**STATEMENT OF PRIMARY EVIDENCE OF GARETH WRIGHT ON BEHALF OF
CHRISTCHURCH CITY COUNCIL**

QUALIFYING MATTER: HERITAGE (LISTED HERITAGE ITEMS)

3. My evidence relates to those District Plan provisions applicable to the removal of the former Dwelling and Setting, 471 Ferry Road (the **Building**) from the Schedule of Significant Historic Heritage Items in Appendix 9.3.7.2 (the **Schedule**) in the District Plan.

**HERITAGE RESPONSE TEAM -
HERITAGE ENGINEERING ADVICE
Post Site Visit (Non Resource Consent)**

sketch:

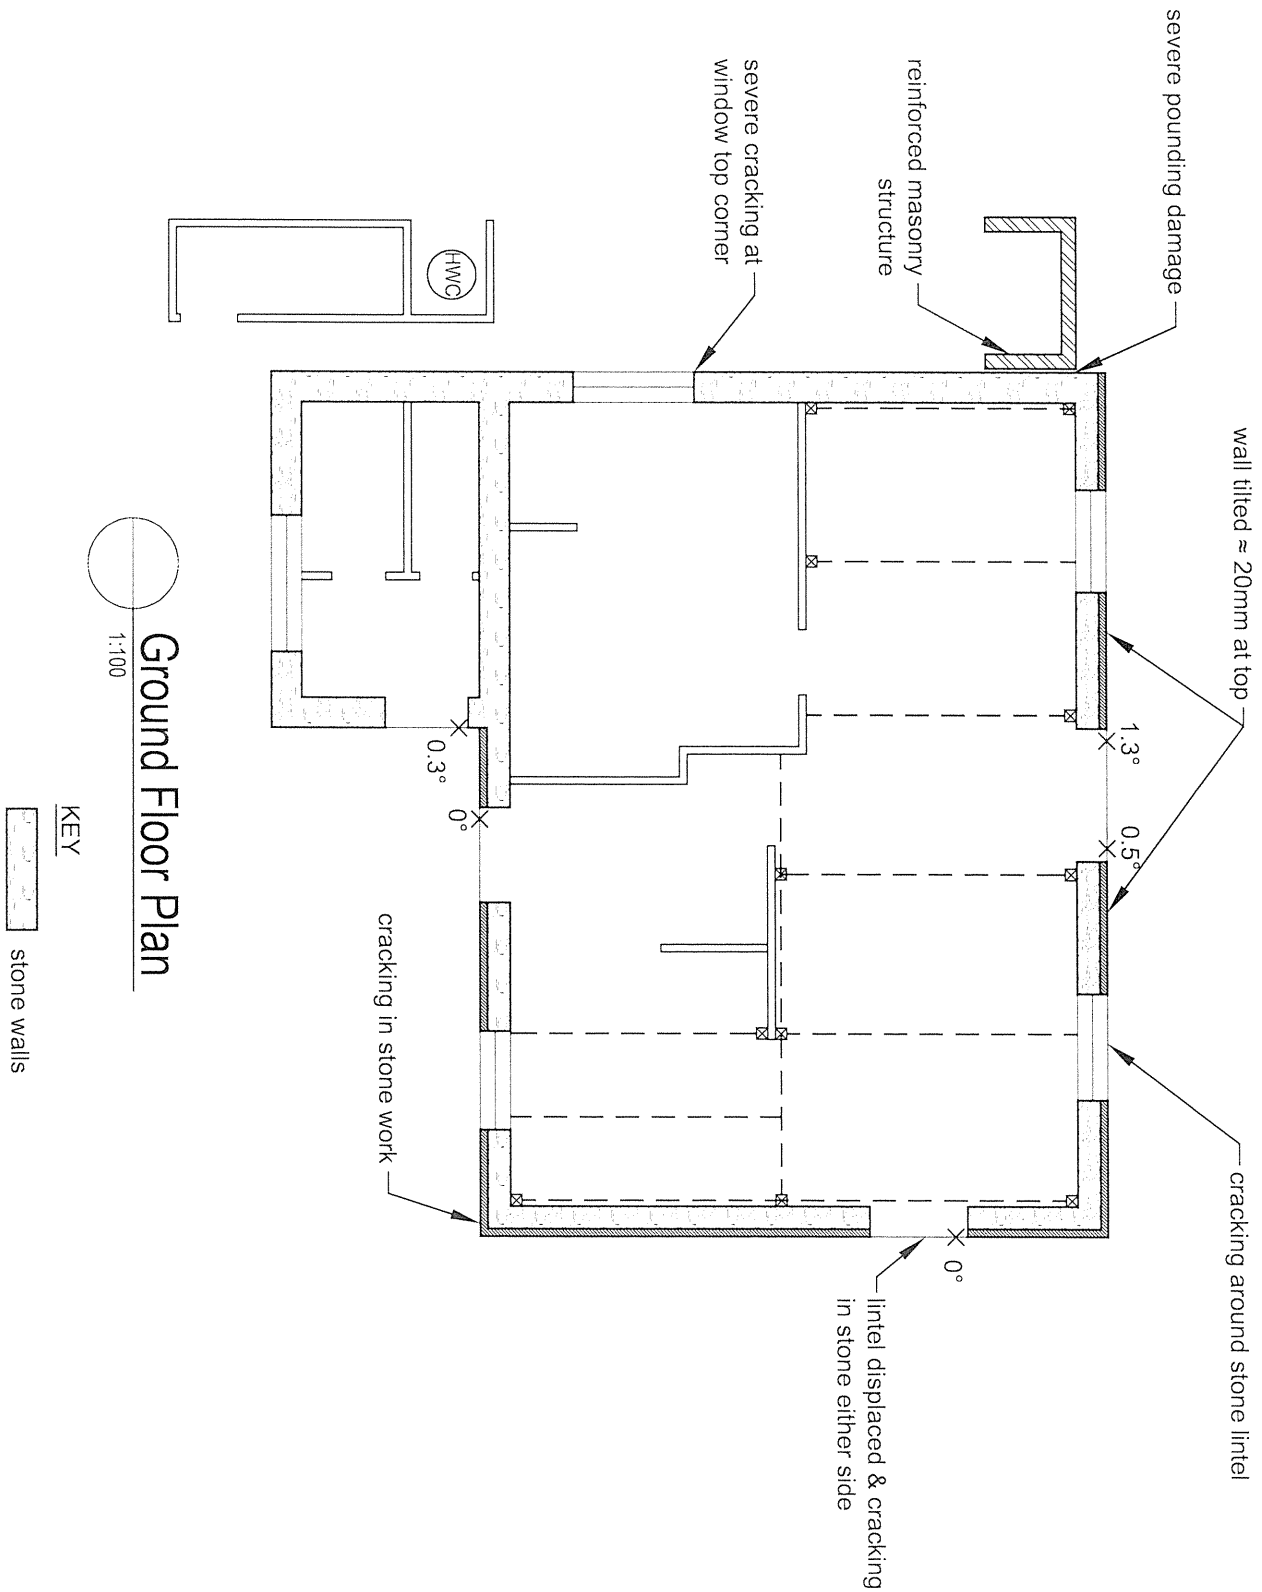
Access to the interior of the building was not possible due to the doors being jammed shut by movement in the stone walls from seismic activity. We therefore conducted an assessment of the buildings exterior only. Please refer to the attached marked-up drawing of the structure indicating the areas of damage. For reference, we were supplied site notes and descriptions of the interior condition by Andrew Russell of MWH Mainzeal from his inspection on 1/02/11, before the second earthquake of 22/02/11.

The stone walls around the perimeter of the building show a large amount of cracking due to in-plane shear stresses, and in places stones have fallen away. In particular, the most severe damage appears to be concentrated in the corners. At the North-West corner of the house there is diagonal cracks about 20mm wide through the mortar. The inherent stability of these walls is likely to be marginal at best.

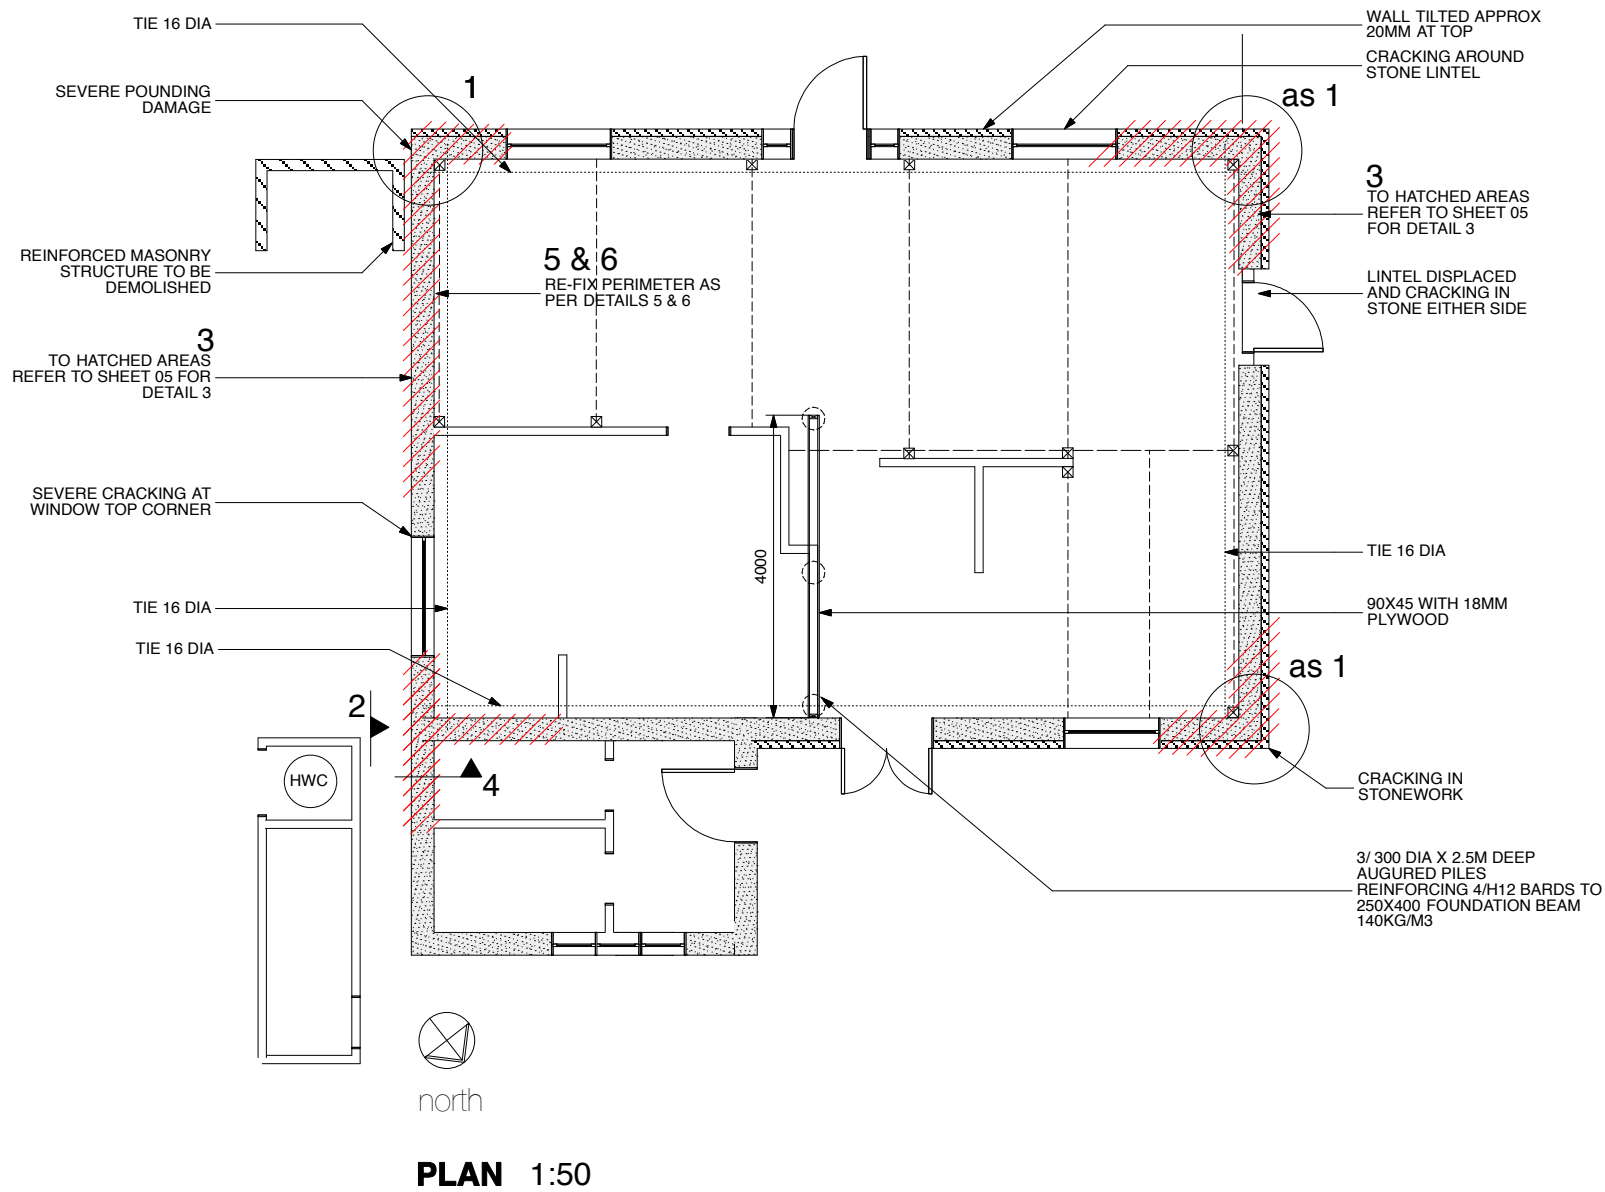
Externally the most severe damage has occurred above the entry door on the western side of the building, where the stone lintel has dislodged and fallen. The photo below shows the area where the stone lintel was and the variable nature of the stone used in the wall with the inner and outer faces being large and worked and the rubble infill being small and un-worked with some mortar bonding the rubble.

The external stone face on the South wall has tilted towards the exterior resulting in a 50mm gap between the stone and the door frame on this elevation. It would appear that the stone face has separated from the rubble infill and the whole wall is leaning as well as shown in the photo below.

“The stone lintel over the door on the western side of the house shows signs of incipient collapse as it has moved away from the adjacent wall. It appears that this lintel is a facing stone approximately 100mm to 150mm thick, as this is the thickness of the stone veneer. There is a greater chance of the lintel toppling in this case as there is less bearing area providing support. There are a number of 1 – 2mm cracks around the other stone lintels on the southern external wall but these are not at risk of collapsing.” At the time of our inspection the stone lintel had collapsed along with some of the rubble infill, as the photo on page 2 above shows. The lintel appeared to be intact

and it can be refitted with ties installed across the width of the wall from the inside to 50mm from the outer face. The tying should be undertaken to the remaining windows and doors to secure the lintels.

“The external wall on the southern side of the building has tilted and the veneer is showing some signs of separating from the original wall. There is a 25mm gap between the stone veneer and timber doorway. This doorway was measured using a digital level and found to be 1.3° out of plumb. According to Jon Donovan there is a 50mm gap between the main stone wall and the ceiling, which he saw when inspecting the interior before the June seismic event. Windows and doorways around the rest of the house are still plumb.” It is likely that the wall can be plumbed, if necessary, using horizontal walers connected to turfs tied through the width of the building and carefully tensioned to move the wall back into position. The wall should then be permanently tied to the roof structure to prevent it moving out again. The inner and outer stone whytes should then be tied together with Helifix Dryfix ties at 400mm horizontally and vertically. The ties should be installed from the inside once the plaster has been removed from the face of the wall.
